RE: Stone Harbor Dredging Permit Modification
USACE Permit: CENAP-OP-R-2015-167-24

Revised Dredging Work Plan Dated July 7, 2016

Dredging Work Plan - **ADDENDUM**

Dredge Material Dewatering and Management Plan - **ADDENDUM**

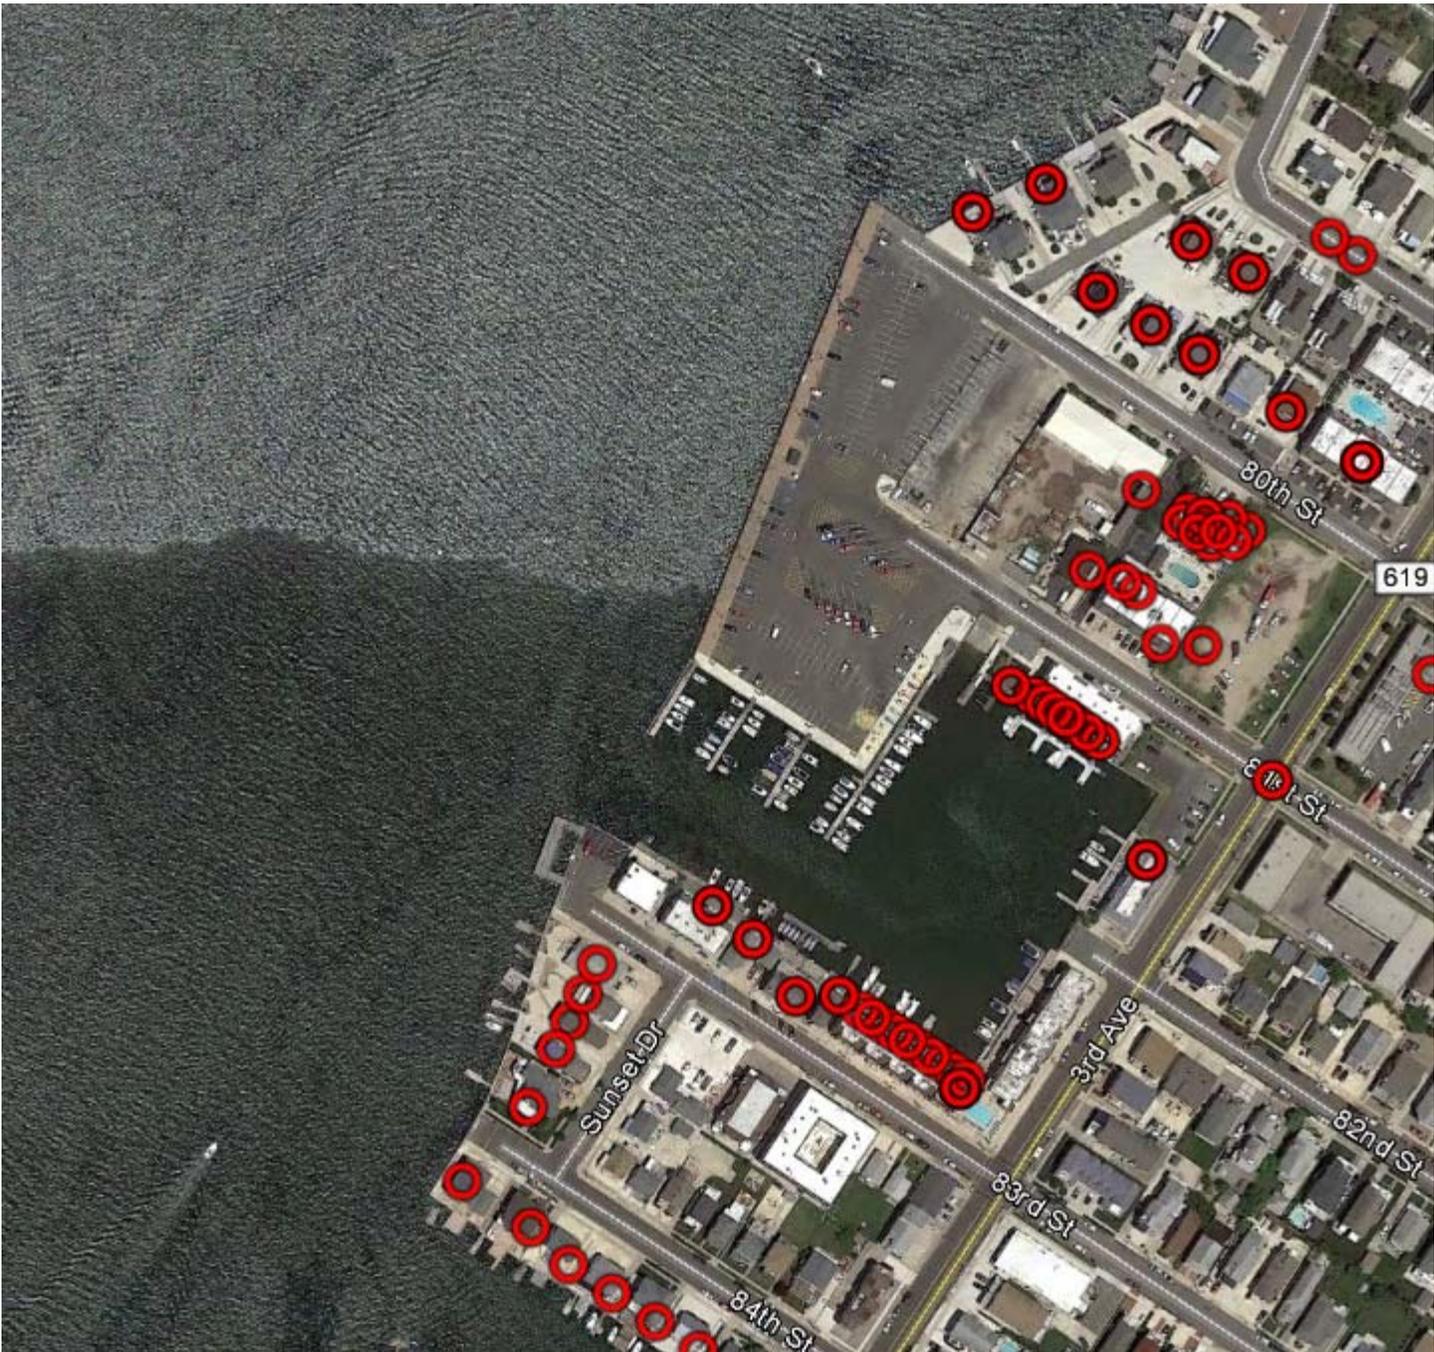
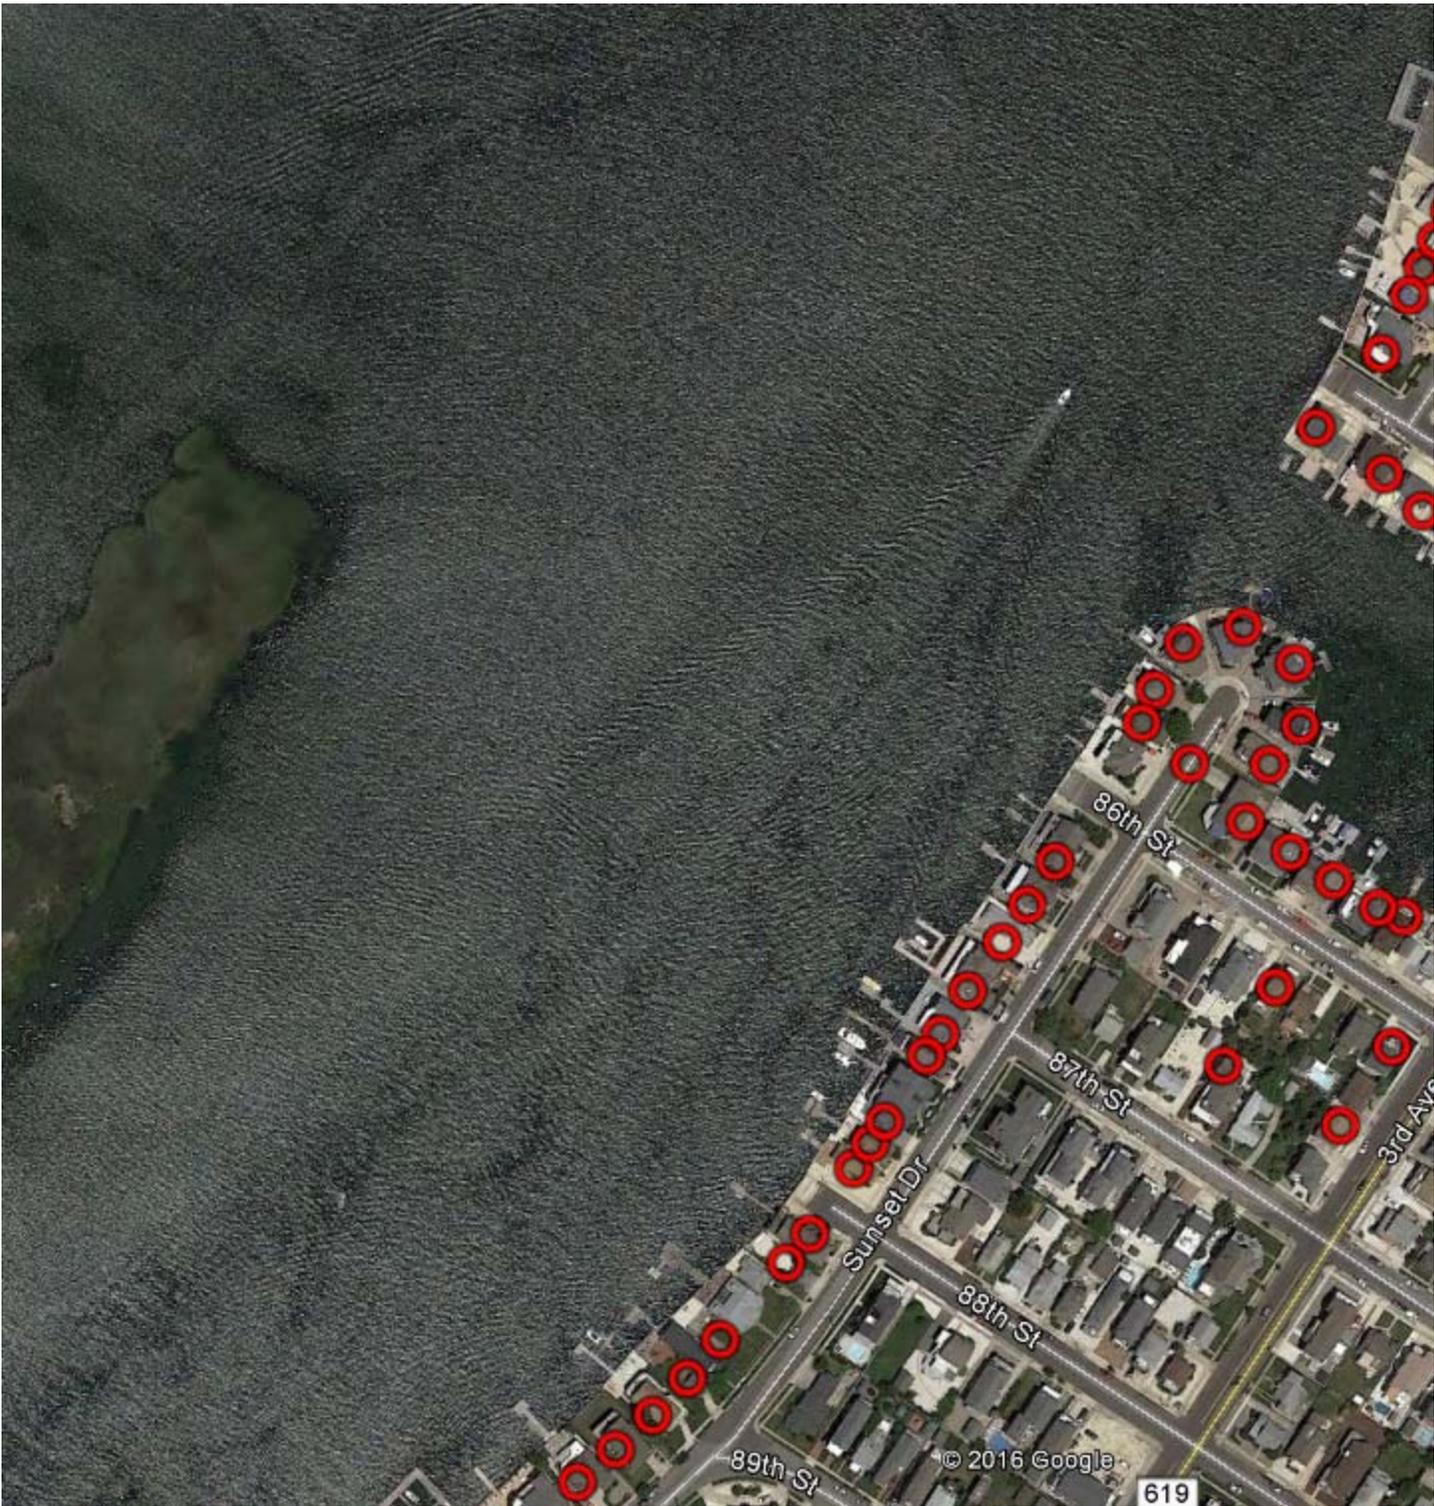
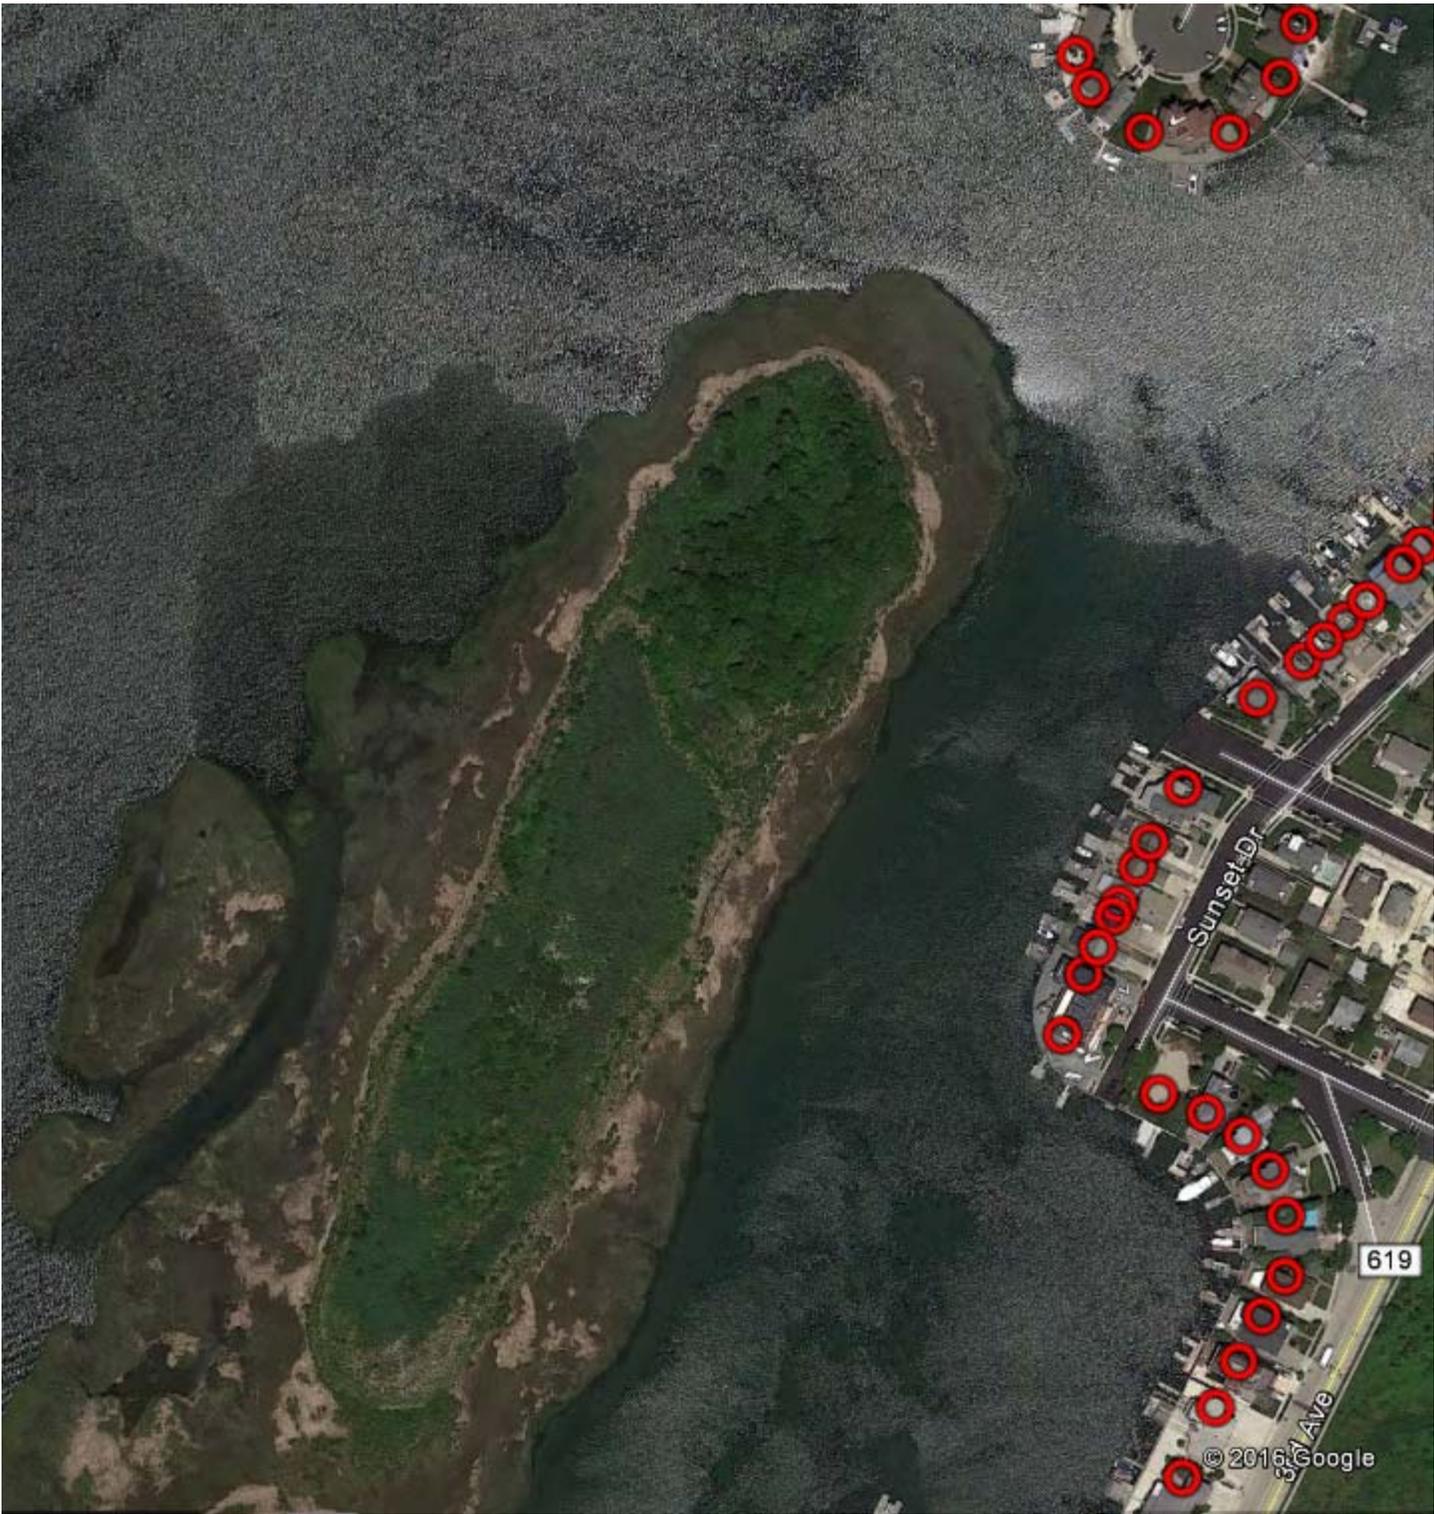
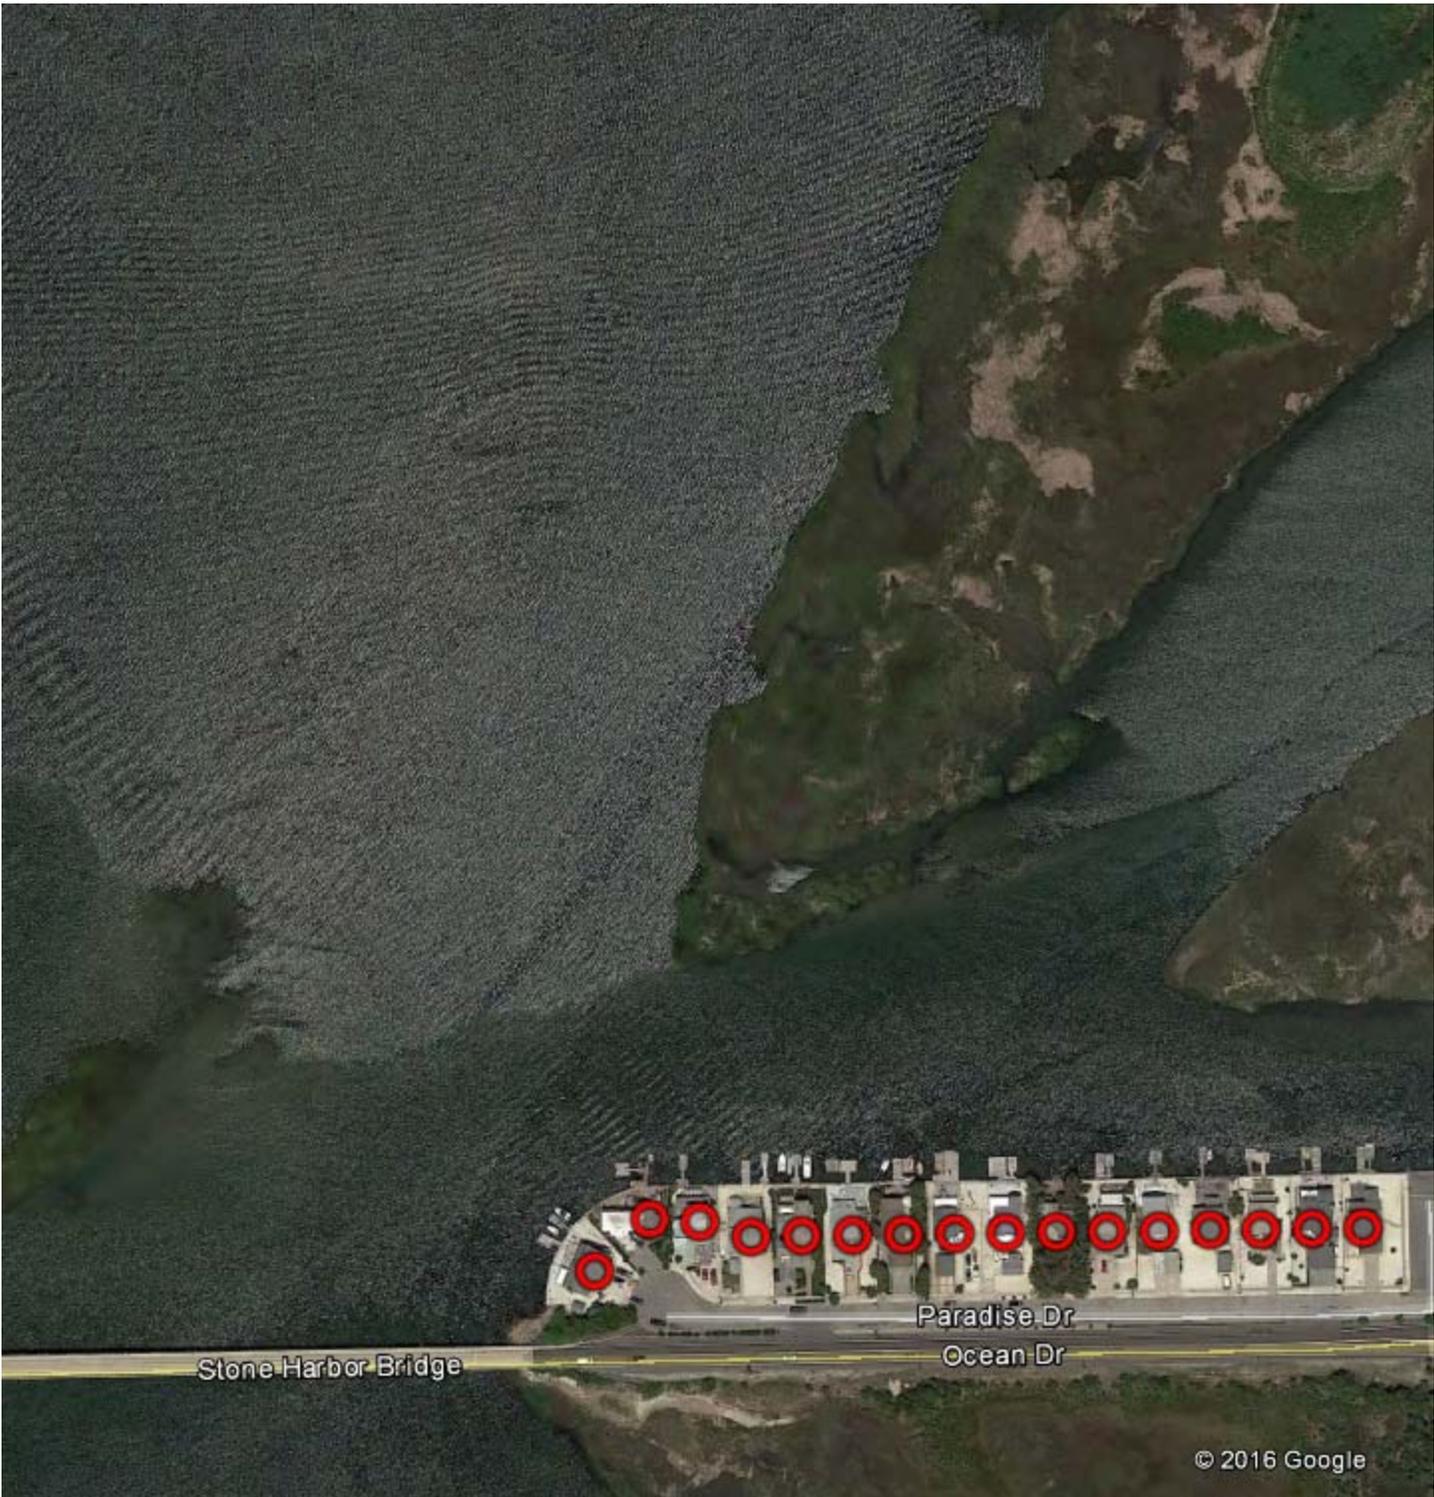
Tim -- Regarding item #2, your proposal to use CCA-treated wood in mapped shellfish habitat will be problematic. NMFS is adamant about not allowing that, and we have been on board with that prohibition for some time. **Sevenson will use untreated southern yellow pine piles. This is different than what we had proposed. The pilings will be temporary so they do not need to last long or have the treatment. They are available from a local vendor. <http://www.marinelumber.net>**

I assume that the mailing list includes, at least, the owners immediately across 80th Street from the site (west of 3rd Avenue/Ocean Drive). Is that correct? For the 2015 notice, we had 534 waterfront owners, and an additional 45 owners adjacent to the dewater site (total 579). You now have 642 total. Is that because you have additional ones for the dewater site? Are the waterfront owners the same?

1. Please clarify the closest distance to the edge of the federal navigation channel (ICW) for: a) proposed pilings or other structures; **pilings will be 268 feet outside of the USACE channel** and b) any moored vessels, including scows or barges. **The barge will be moored on the pilings 253 feet outside of the USACE channel limits. Please see attached drawing showing the UASCE channel (SEVE-3718-WEST-OF-NORTHBASIN-SHEET1).** I see you located red channel markers on the survey. Are those on the far side or near side of the channel? You have two different arrangement of barges/scows: one on the site layout plan and one on the survey. One way gets you closer to the channel than the other. Please clarify.

3. There is mention of a “personnel pier,” presumably to go in the basin or marina. Same as the fender piles, that would need authorization even if only temporary. That should be shown on plans, along with the materials. This has been added to the plan for the site layout. It will be two 40x10 barges pinned together and held in place with two spuds. A sample photo is provided in the NMFS document. The pier has been added to the pan sheet also (Site Layout 7-25-16).

We imported the address into google earth so I think it gives you an idea of who gets the letters. Waterfront people/list are the same, then we added the people within 200 feet of the marina. The people within 200 feet of the marina database was generated by the Boroughs tax assessor. See photos below. The dots in the middle of the road are because google earth could not figure out how to exactly map the address.

Note that the letters sent to the NJDEP and the labels provided to the NJDEP are for the permanent mailing address.
